TECHNICAL SERVICE BULLETIN																			
DATE ISSUED		MODEL YEAR(S) AFFECTED			MODEL(S) AFFECTED			TSB #											
2/7/00		1998-2000			Diesel Pushers			190											
BRAND					TYPE														
All	<input type="checkbox"/>	American Star	<input type="checkbox"/>	Kountry Star	<input type="checkbox"/>	Dutch Star	<input checked="" type="checkbox"/>	All	<input type="checkbox"/>										
NewAir	<input type="checkbox"/>	Mountain Air	<input checked="" type="checkbox"/>	Kountry Air	<input type="checkbox"/>	London Air	<input checked="" type="checkbox"/>	T T	<input type="checkbox"/>										
								F W	<input type="checkbox"/>										
								C A	<input type="checkbox"/>										
								D P	<input checked="" type="checkbox"/>										
								D B	<input type="checkbox"/>

Subject: **XC Side Radiator Hydraulic System**
FL243AD U.S.
FC243AD Canada

Recall Bulletin

Subject: XC Side Radiator Hydraulic System

Fig. 1, Installation of Hydraulic System Accumulator

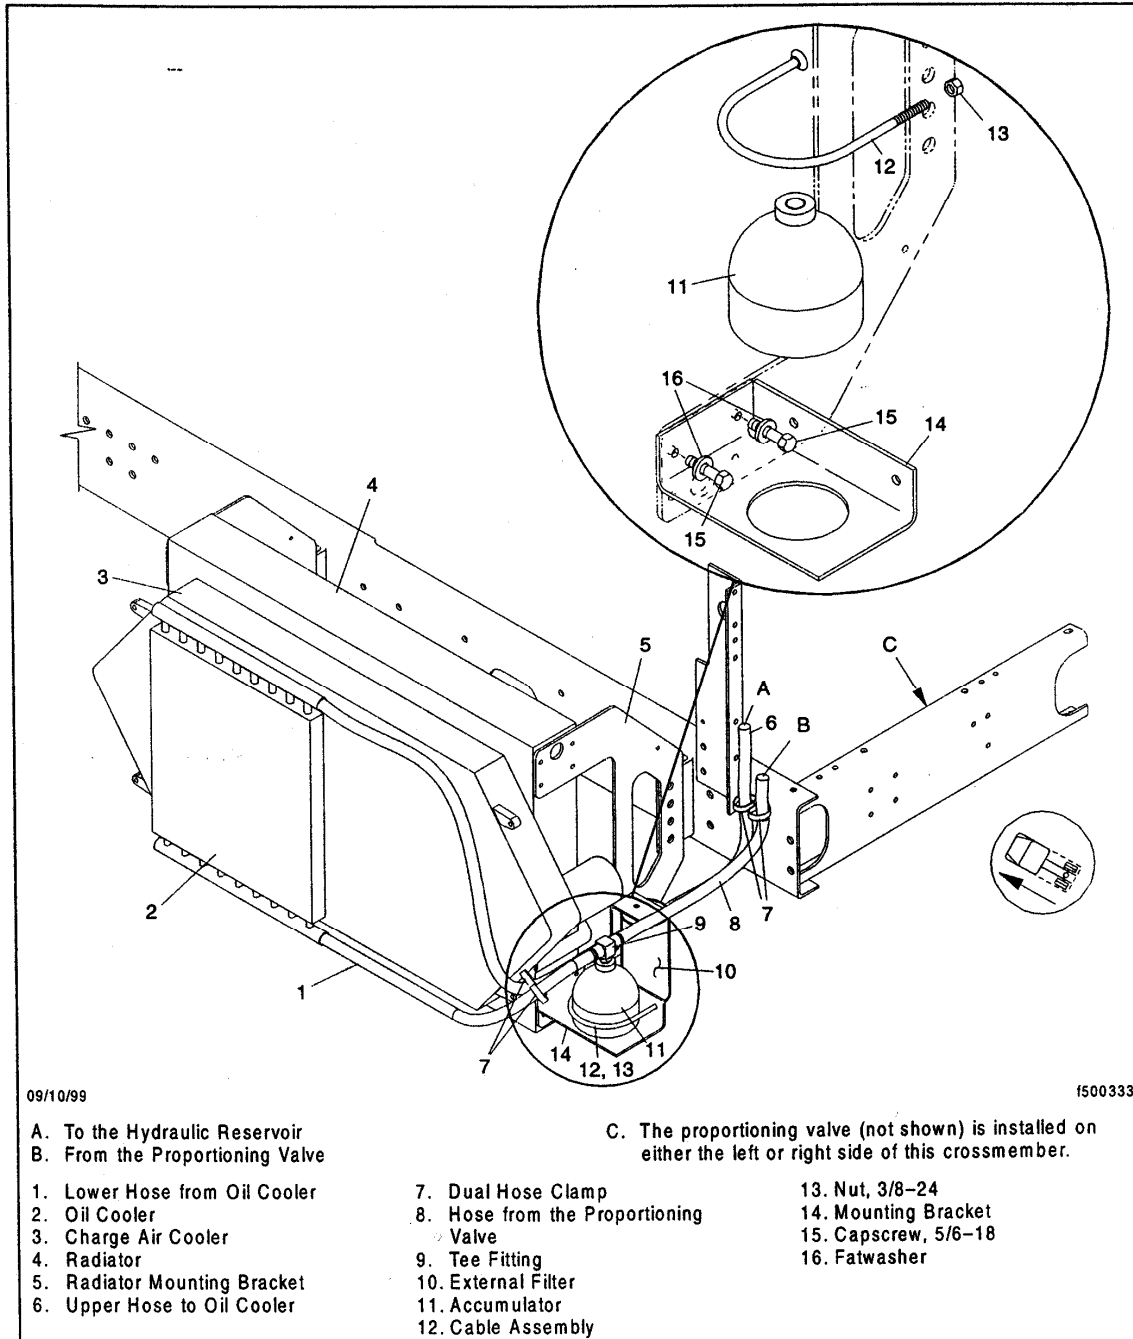
The filter gasket for the power steering hydraulic fluid may blow out due to pressure spikes in the system. This can result in a loss of power steering fluid and an eventual loss of power assist to the steering if the leak is undetected. The vehicle will retain mechanical steering capability.

The modification consists of adding an accumulator to the hydraulic system on all vehicles. The external filter should also be removed from vehicles equipped with a metal hydraulic fluid reservoir.

4. Put a clean container under the power steering reservoir and disconnect the supply hose from the reservoir to drain the system.
5. Disconnect and remove the hose connecting the proportioning valve to the lower end of the oil cooler. See Fig. 1.

8. Install the Tee-fitting onto the accumulator and tighten 20 lbf-ft (27 N·m).
9. Seat the accumulator onto the mounting bracket. See Fig. 1.
10. Using the cable assembly and the 3/8-24 nut, secure the accumulator to the bracket. See Fig. 1. Tighten the nut 30 lbf-ft (40 N·m).

13. Using two dual hose clamps, secure the hoses together. See Fig. 1.
14. Check the type of power steering reservoir.

If equipped with a 12-quart metal reservoir, check for an external filter near the oil cooler, in the hydraulic hose running from the top of the oil cooler to the reservoir. See Fig. 1.

If the filter is present, remove it and connect the hose ends using a union fitting from the kit. Tighten the fittings 20 lbf-ft (27 N·m).
- IMPORTANT:** Remove the external filter *only* if equipped with a metal reservoir. If the vehicle is equipped with a plastic reservoir, do not remove the external filter; leave it in place.
15. Fill and bleed the hydraulic system. See **Group 46** in the chassis workshop manual for instructions.
16. Close the rear engine access cover.
17. Clean a spot on the firewall under the dash on the driver's side, and attach a completion sticker (Form W-147). The sticker should reference the recall number and the date the work is done.
